1. INTRODUCTION

This instruction sheet contains the procedure required to install AMP mandrels No. 69411-□ and 69551-□ of the modified design. The design was changed to increase the tail length of the mandrel so that it extends over the stabilizer bar on the guide rib inside the tool as shown in Figure 1. Before the mandrel is installed, the stabilizer bar on the guide rib must be filed at an angle as shown. Mandrels of the previous design may also be used in tools with the modified guide rib.

Figure 4

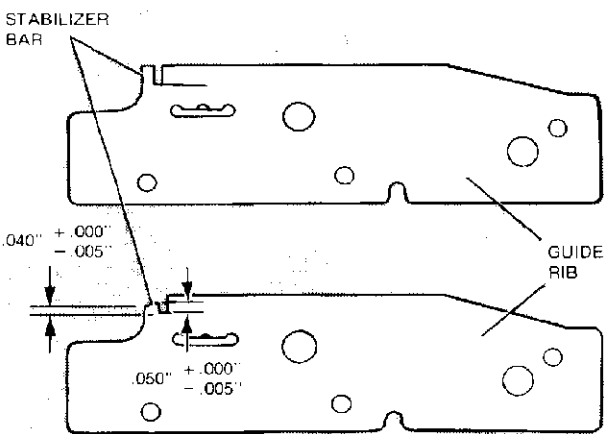
- (a) Remove clips from tool.
- (b) Remove insulation ejector. See Figure 2.
- (c) Remove mandrel holding screw and alignment foot from front of tool.
- (d) Remove mandrel.
- (e) Hold tool by handle and push rear of tool completely forward.
- (f) Remove body assembly from front of tool by driving out roll pins. See Figure 3.
- (g) File the stabilizer bar on the guide rib to the dimensions shown in Figure 4.
- (h) Reinstall the body assembly, mandrel, alignment foot, and insulation ejector.
